Subject: Change Oder 005- Midway Branch Force Main Conflicts and other Scope Modifications

Change Order 005-Midway Branch Force Main Delays

Change Order No. 05
Corporate Dr Segments 4&5
Project No. G1124 &G1125

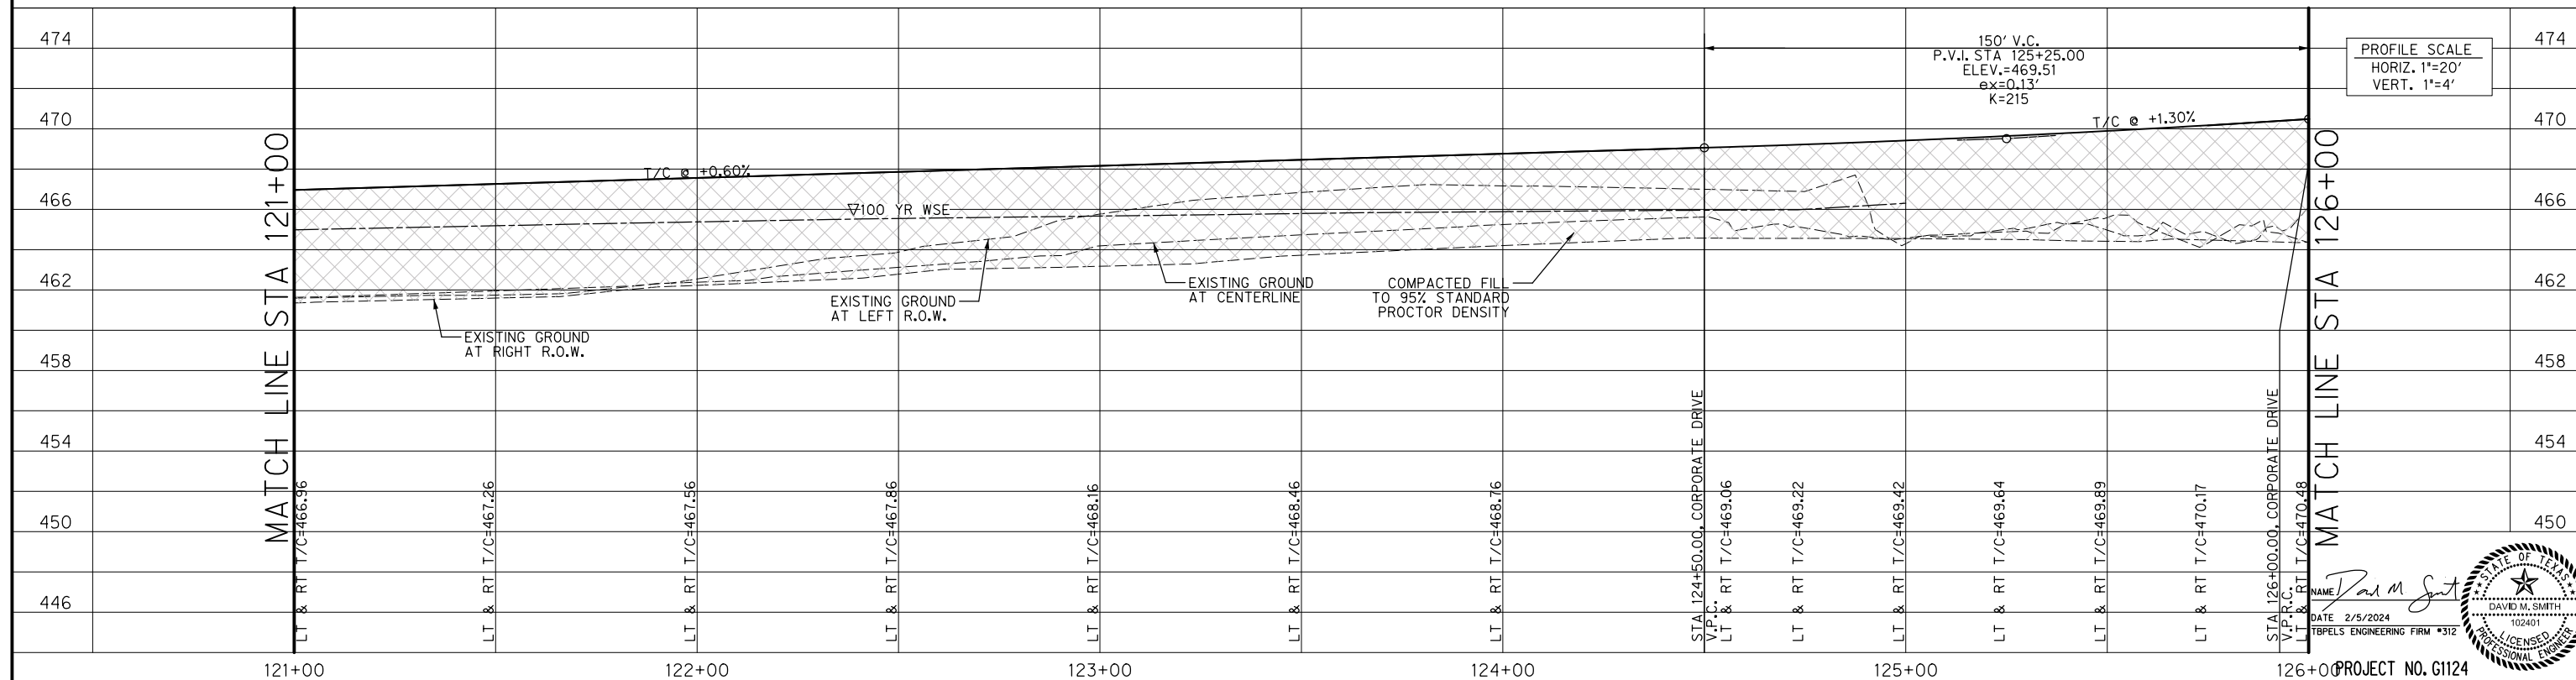
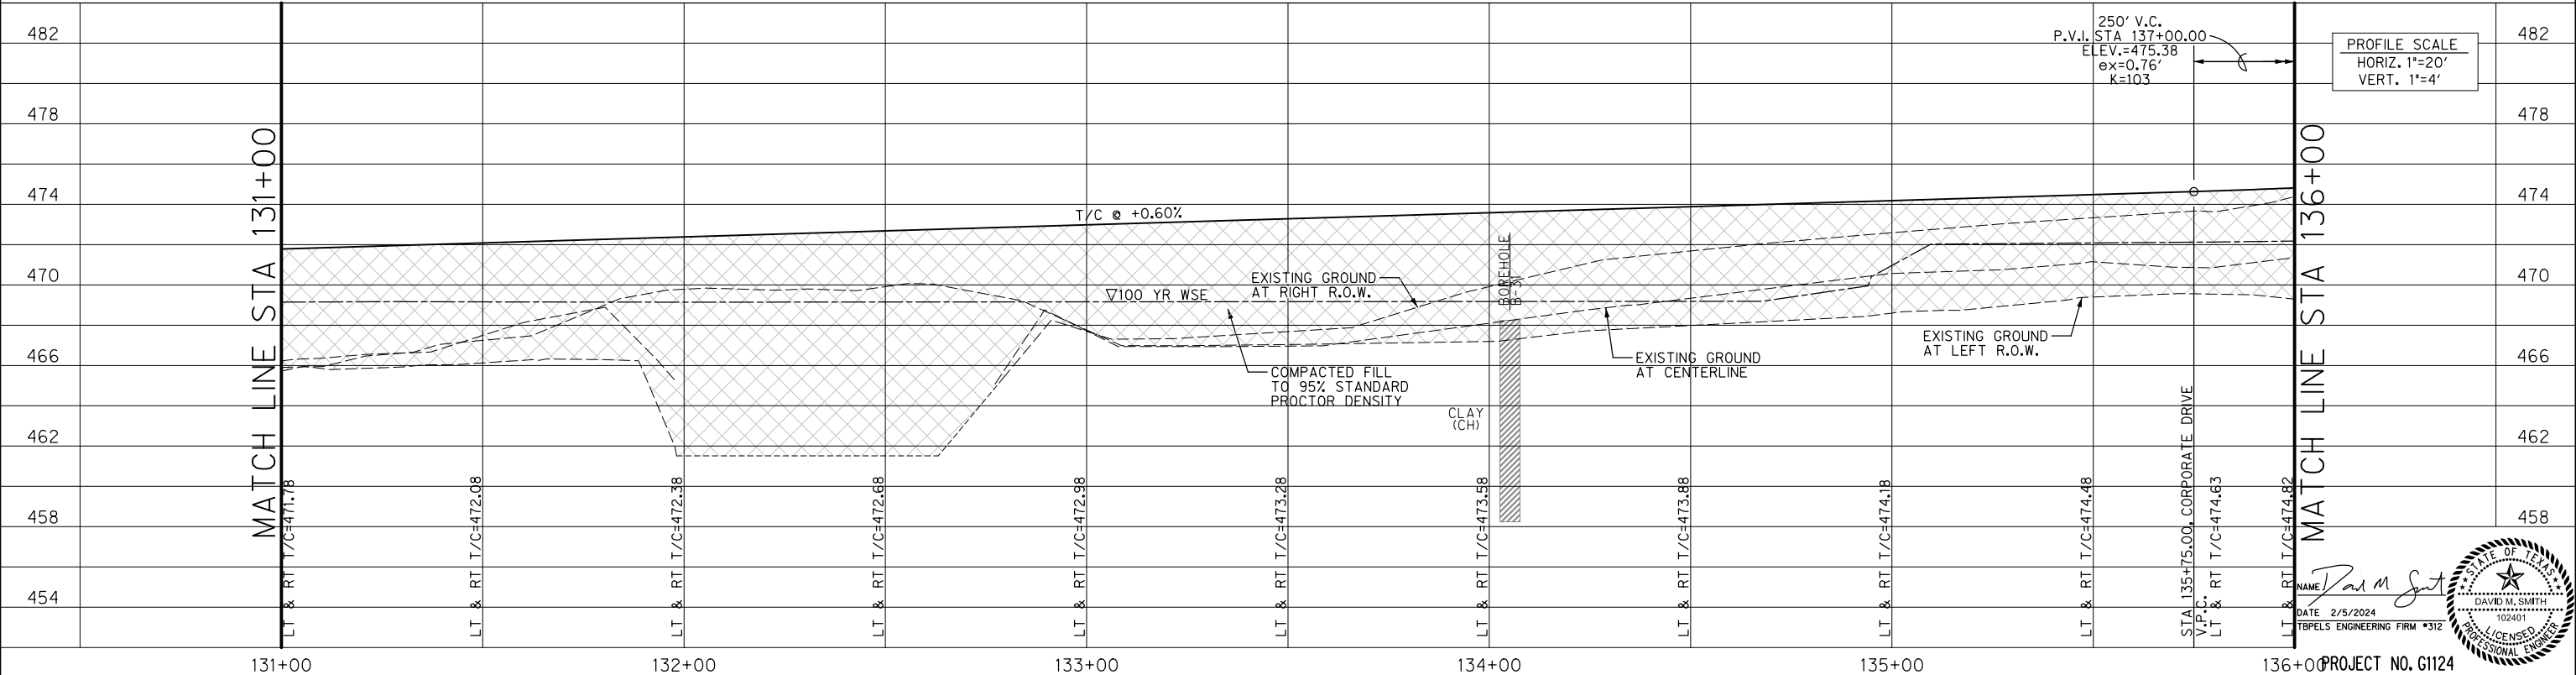
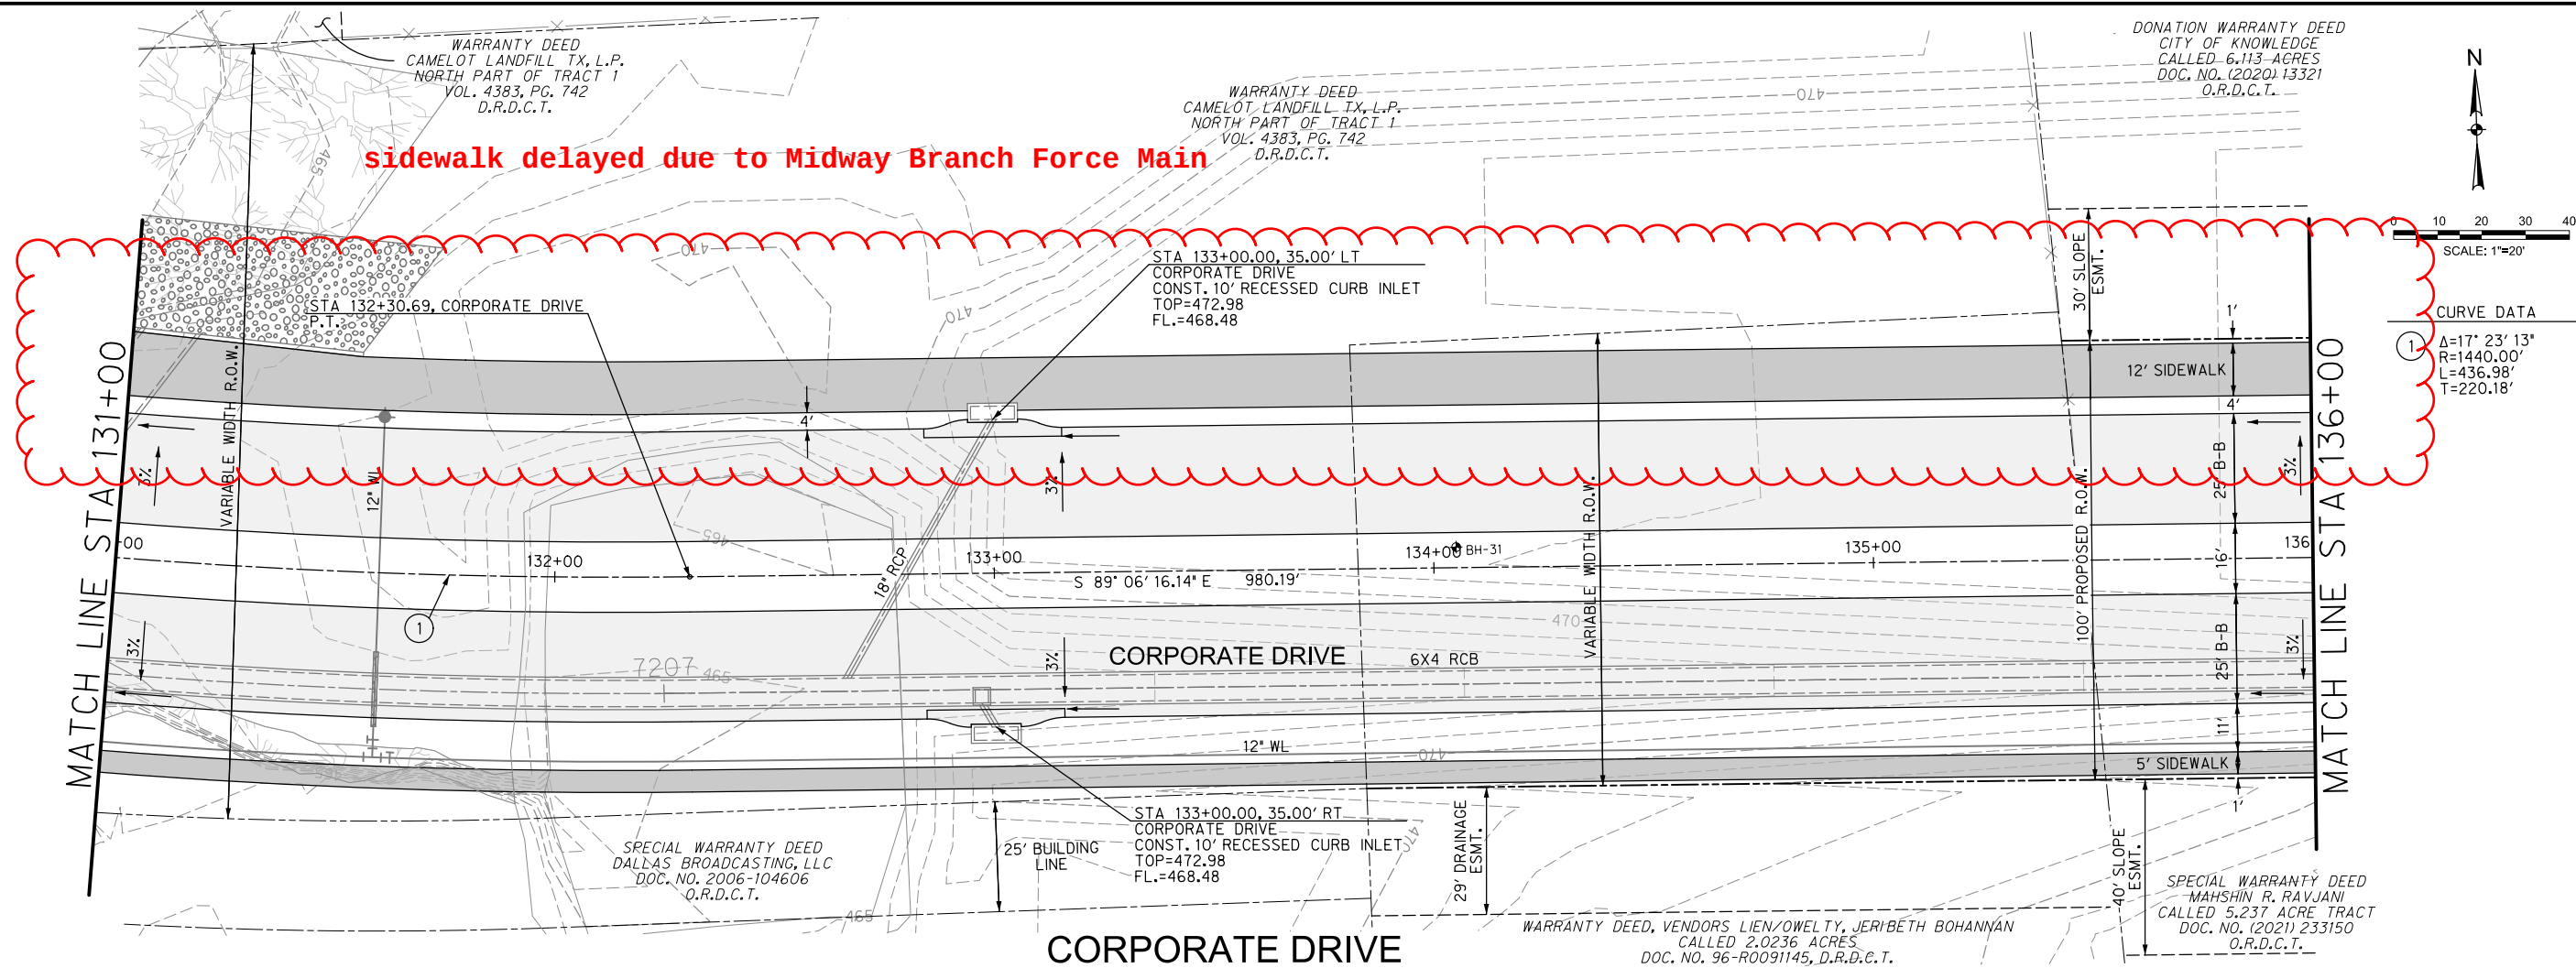
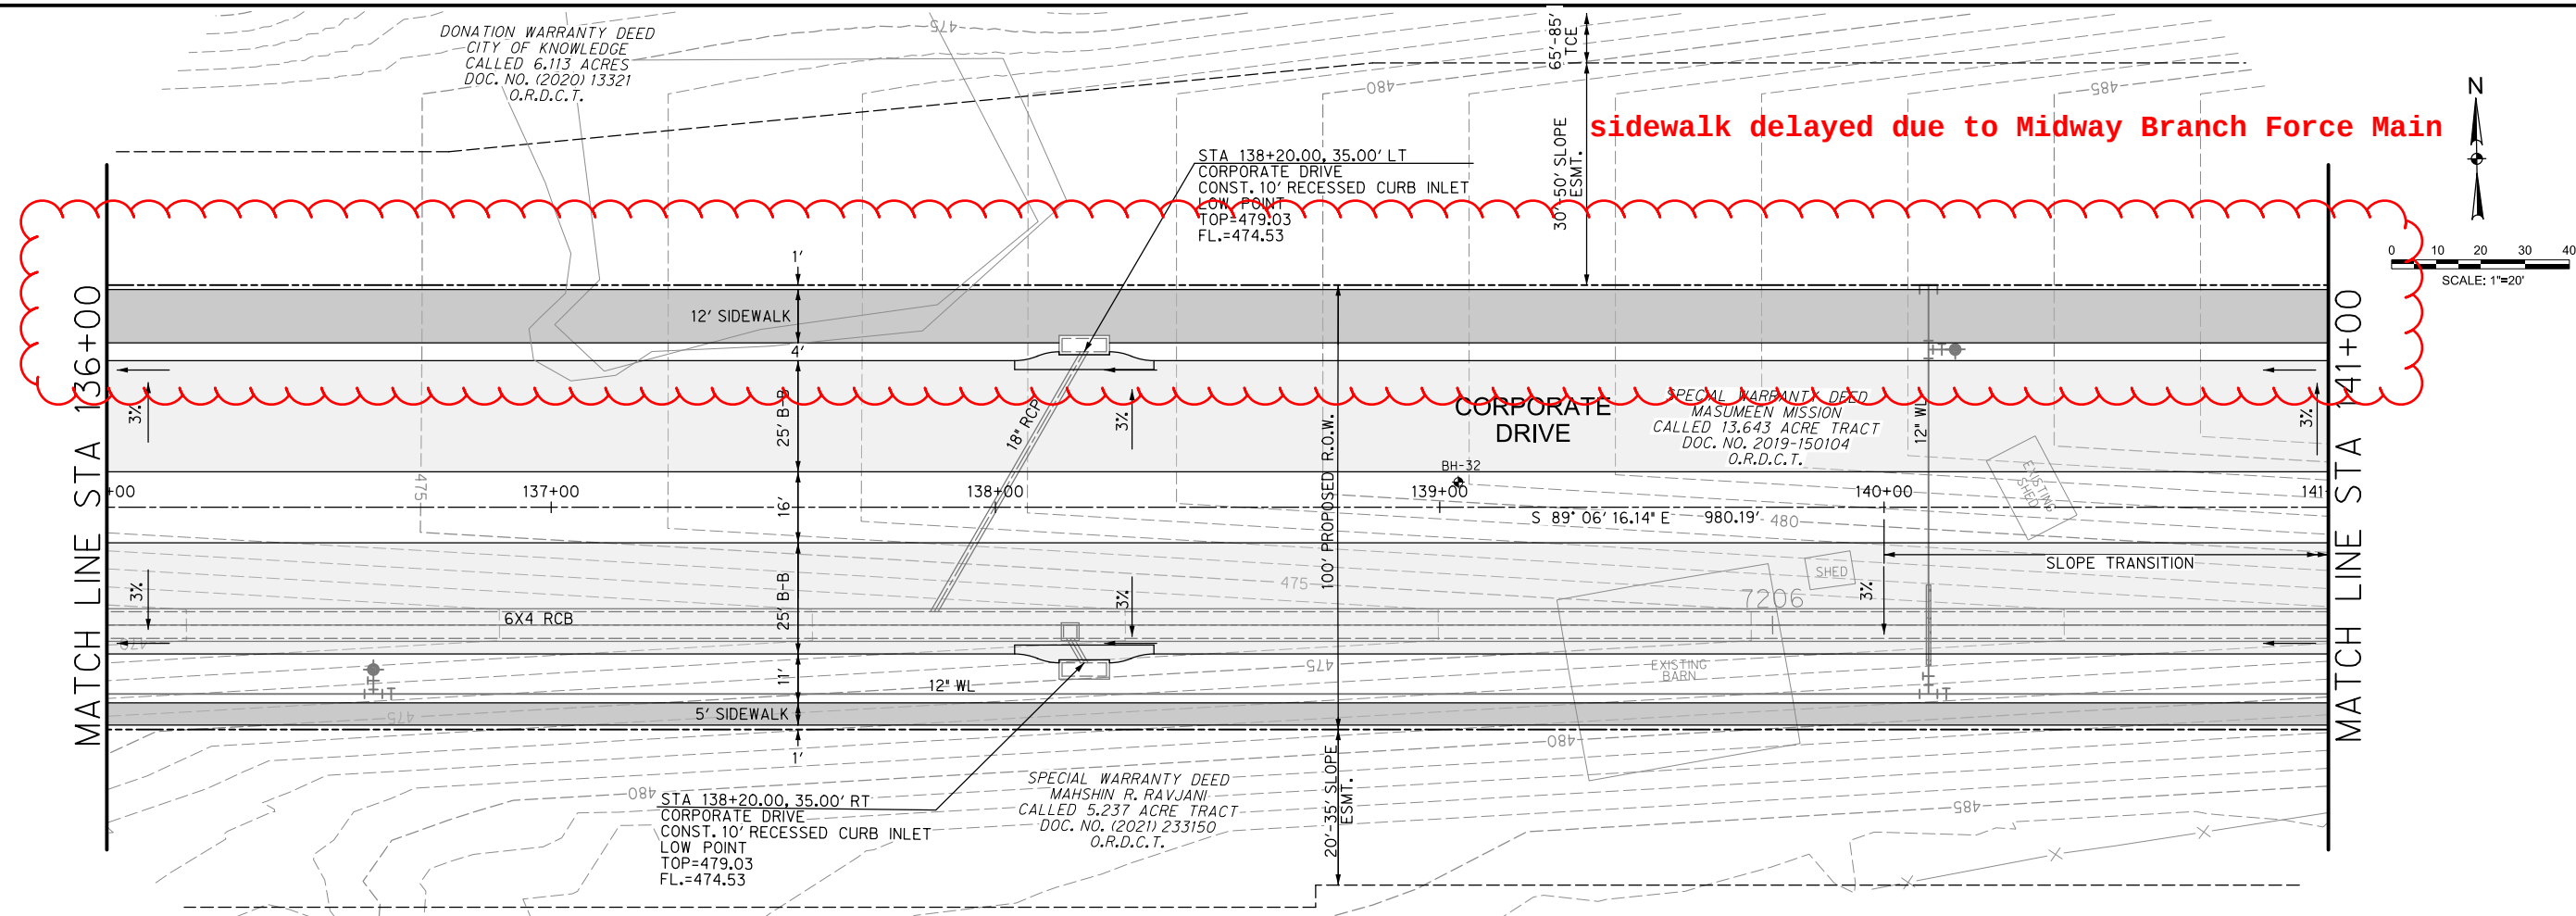
sidewalk delayed due to Midway Branch Force Main

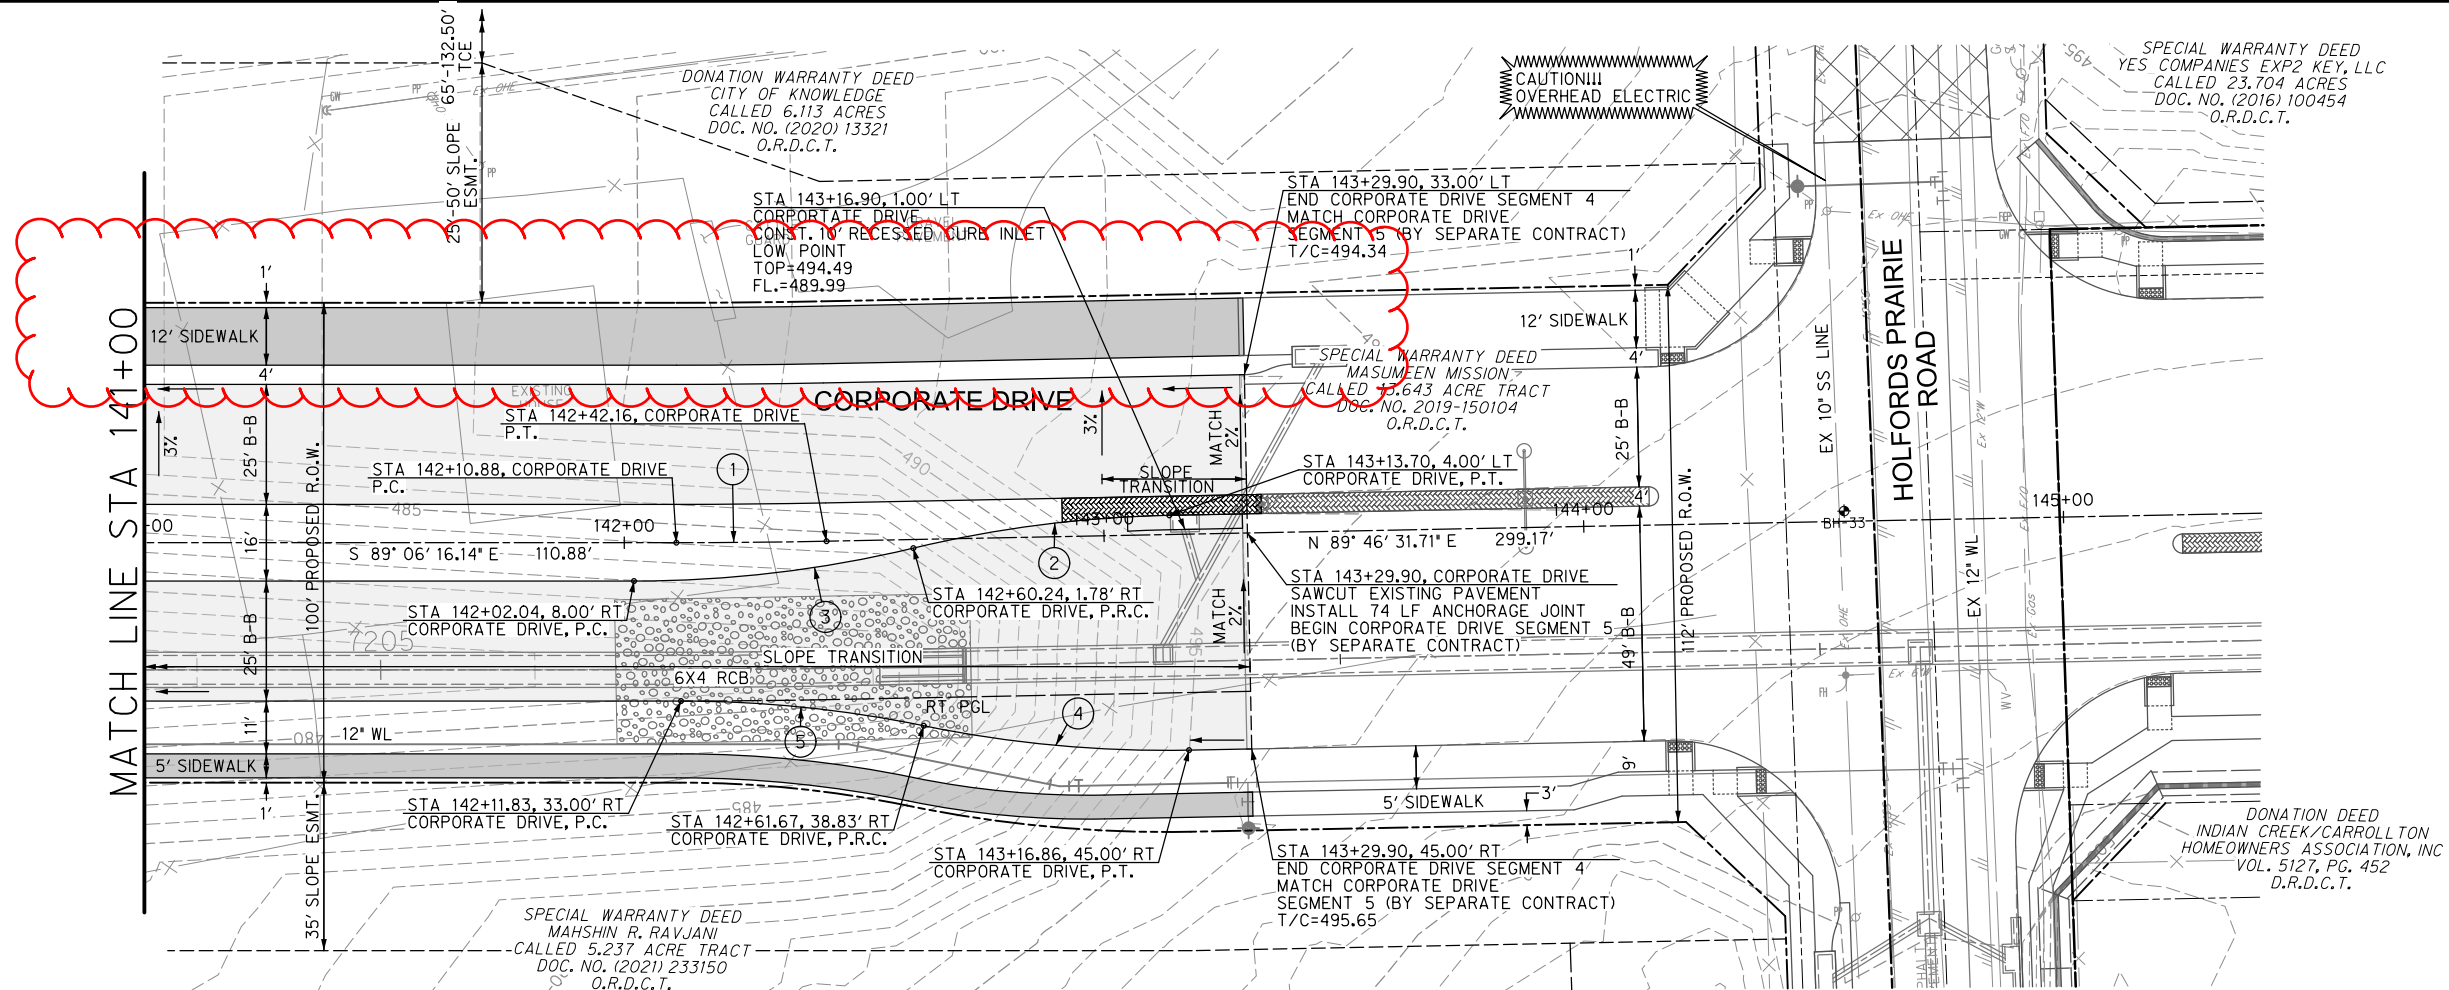
sidewalk delayed due to Midway Branch Force Main
